City of Tacoma TPU / Tacoma Rail Locomotive Simulator Software Upgrade RFP Specification No. TR21-0479F

QUESTIONS and ANSWERS

Pictures requested above in question 4.

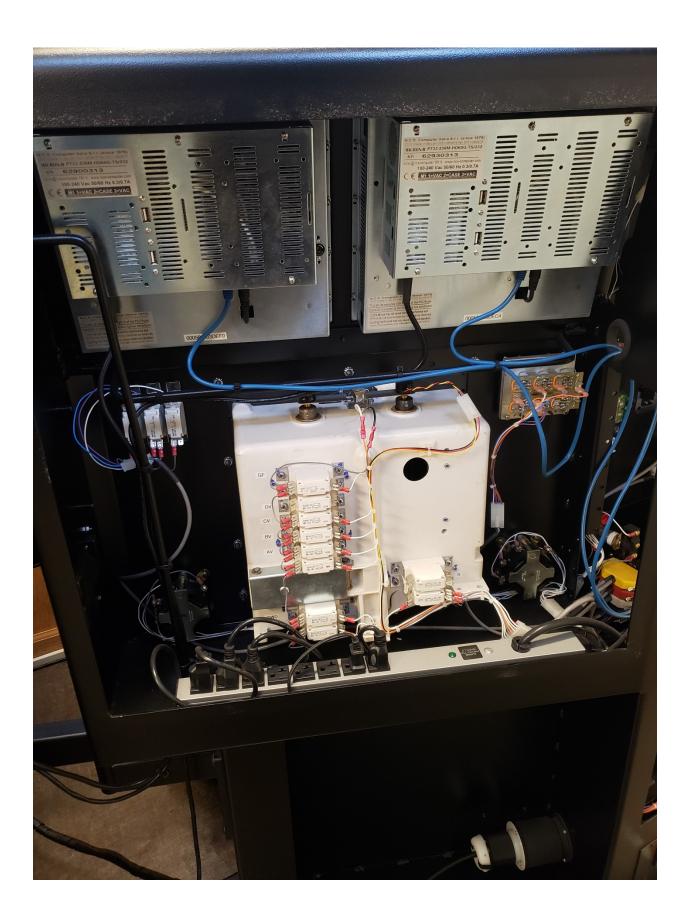
Question 4: Would it be possible to get some pictures of your current stand including front and rear views?

Answer 4: See pictures below.
